**ADDENDUM
NO. 2**

**LOWELL HIGH SCHOOL OLD POOL INFILL
AND RELATED WORK
Lowell, IN 46356**

ADDENDUM TWO

Addendum Two (AD.02) to the drawings and specifications prepared by Gibraltar Design for **Lowell High School Old Pool Infill and Related Work** for Tri-Creek School Corporation, Lowell, Indiana.

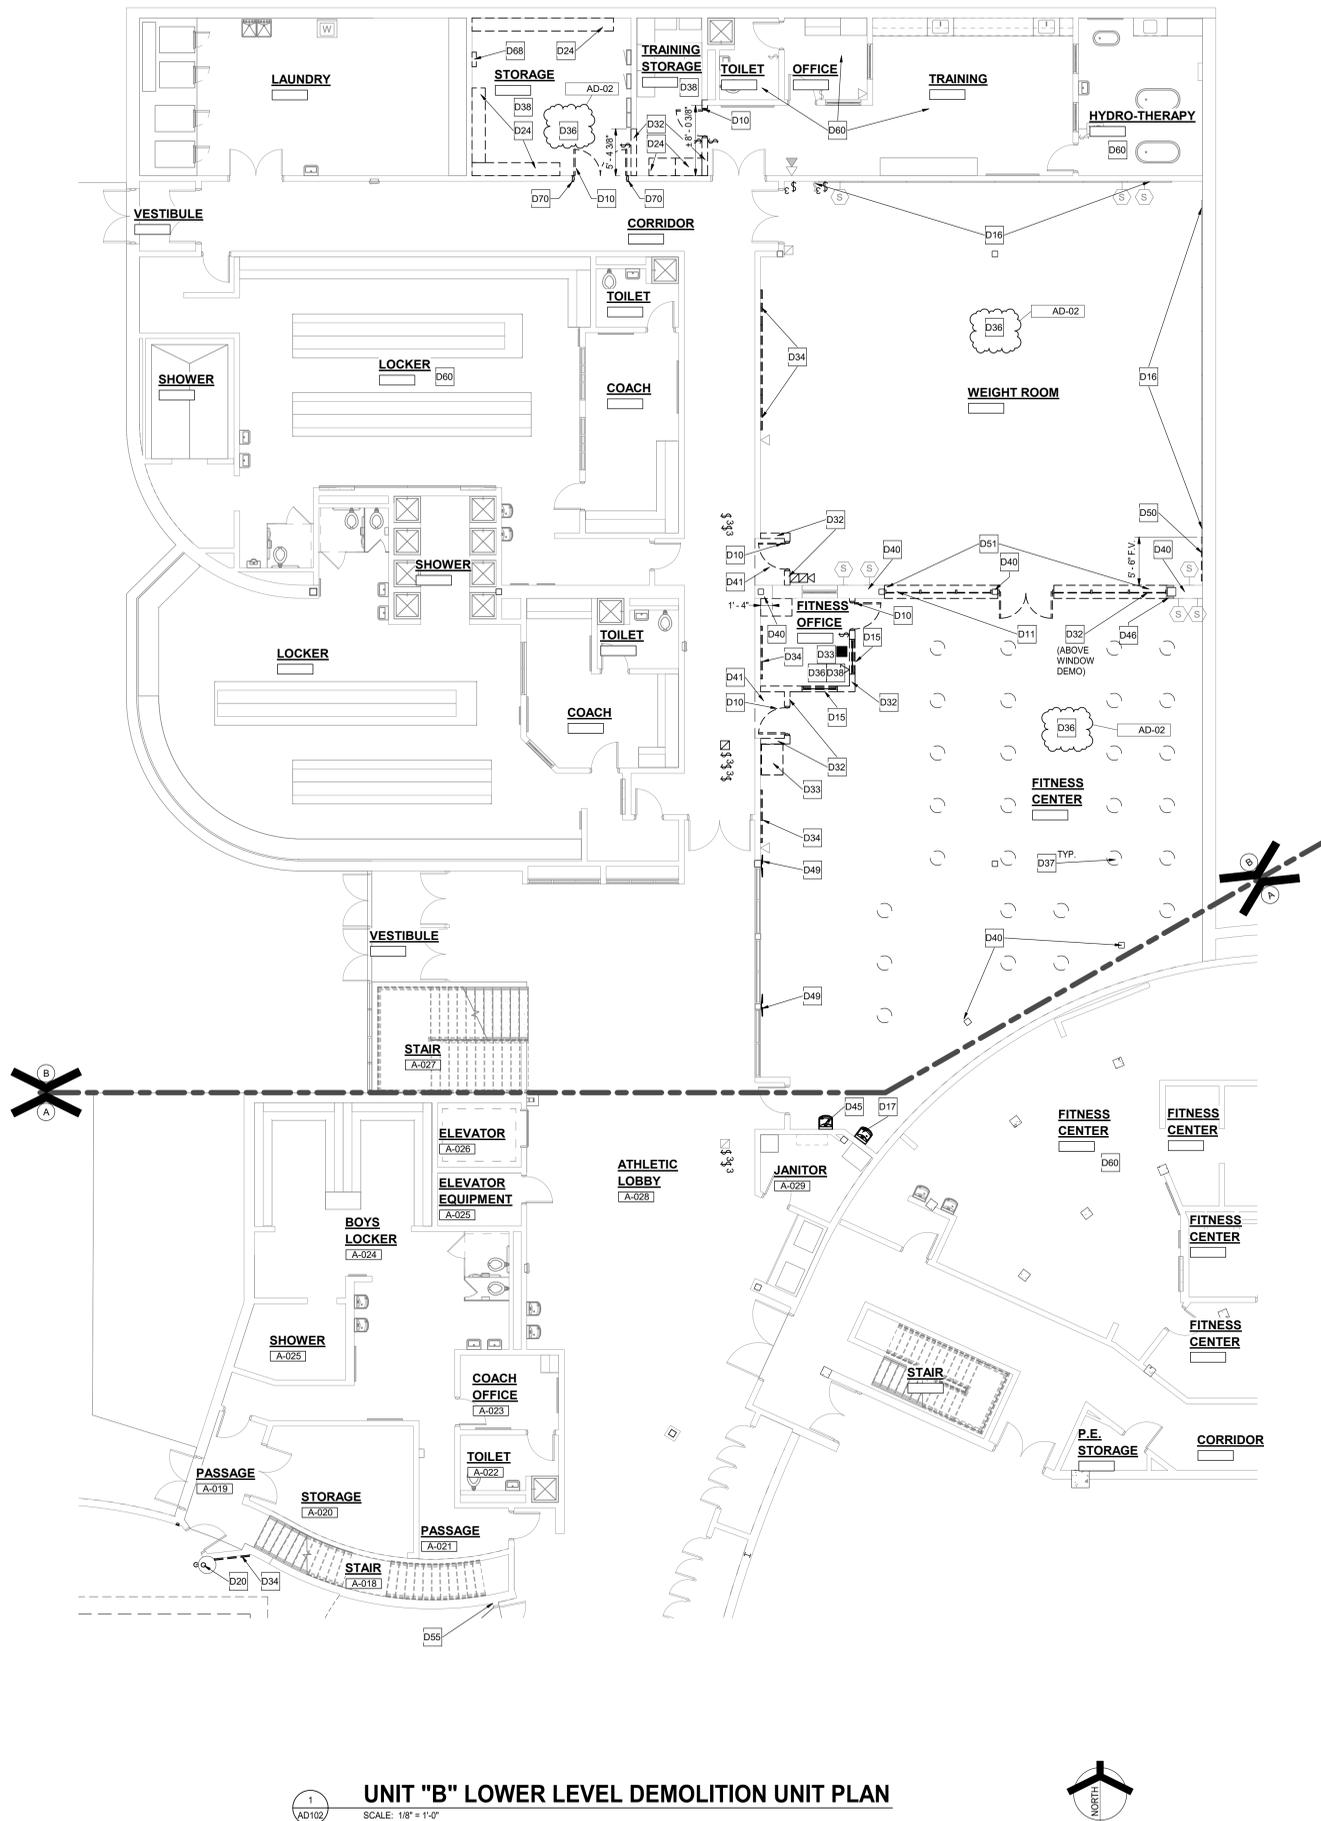
4. **Sheet S-102**
 - A. At detail 2, the west side of the slab shall be doveled into remaining slab at corridor per 8/S-401. The remaining perimeter abuts foundation walls with a thickened slab and isolation joint per 8/S401
5. **Sheet S-402**
 1. At Detail 3 remove the reference the new concrete pad. The concrete pad is existing.
6. **Sheet AD-102**
 - A. Refer to revised full-size drawing included in this Addendum for the following revision
 1. Added floor demolition note in existing Fitness Center, Weight Room, and Storage.
7. **Sheet A-630**
 - A. Clarification – at details 4, 5, and 9, replace the term "metal column cover" or "aluminum column cover" with "PREFINISHED ALUMINUM COVER"
8. **Sheet A-820**
 - A. Refer to revised full-size drawing included in this Addendum for the following revision
 1. Clarification of Ceiling types and Sport Flooring
